1.2 Basement

1.3 First Floor

Tree Impact Assessment Plan

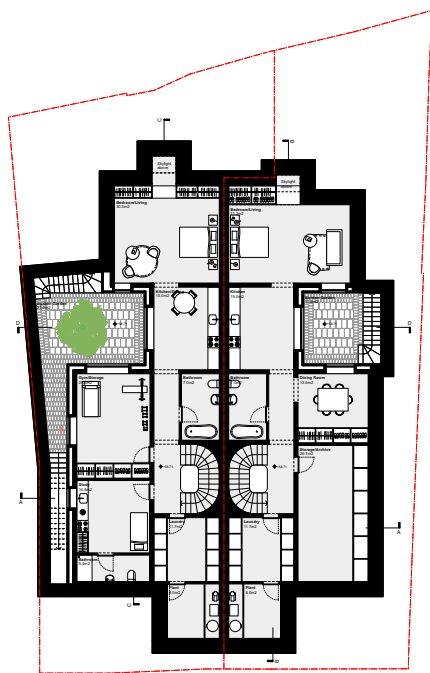
A revised arboricultural report is also attached to this application as requested by tree officer. The tree impact assessment plan shows that only 1% of the tree root protection is affected by the revised proposal, so the potential impact is considered negligible.

Basement Floor Plan - Proposed

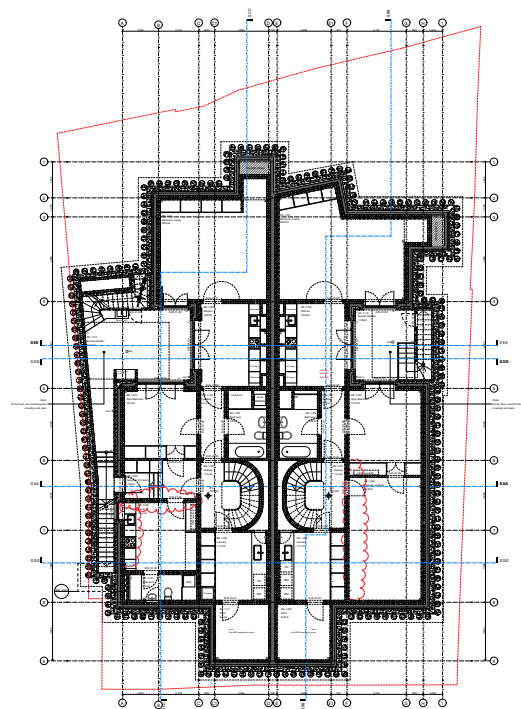
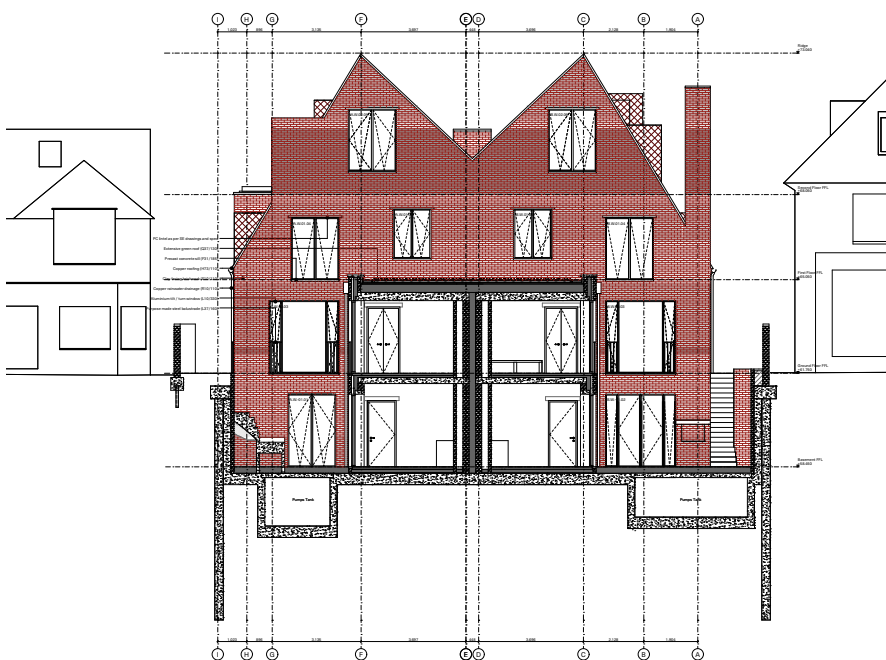
The footprint of the basement changes to follow the massing above ground and generate better internal spaces. The revised position of the 2 skylights at the back further improve the qualities of the affected internal rooms.

The proposal is to also set the basement slab approximately 300mm deeper than the consented scheme. This change will allow for slightly larger windows and therefore improved daylight conditions within basement rooms. This change will have virtually no impact on the external appearance of the building.

First Floor Plan - Proposed

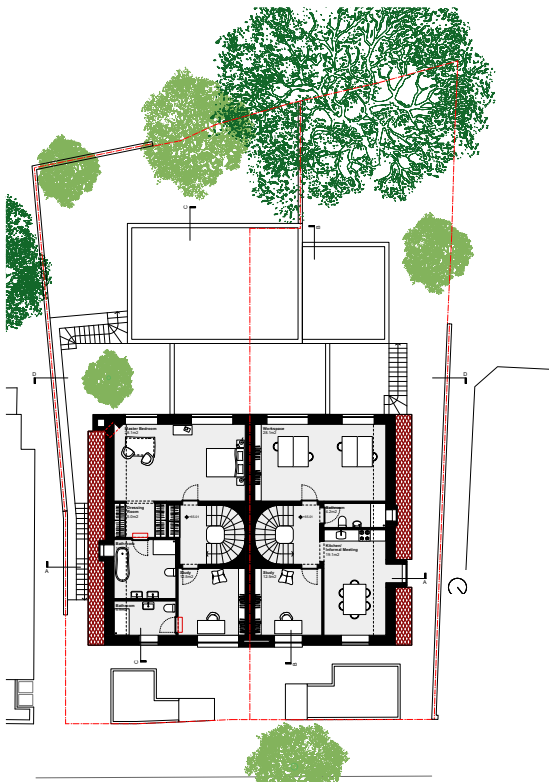
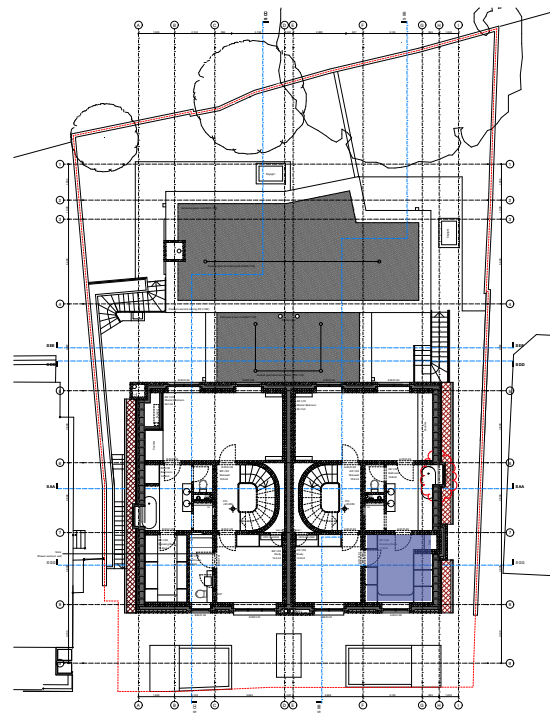
With the exception of the room highlighted in blue below, the first floor layouts suffered only minor changes. The room highlighted in blue changed from being a kitchenette to a dressing room. Due to issues of privacy and overlooking, the dormer (highlighted in blue) on the west elevation associated to this dressing room is now proposed to be a rooflight.
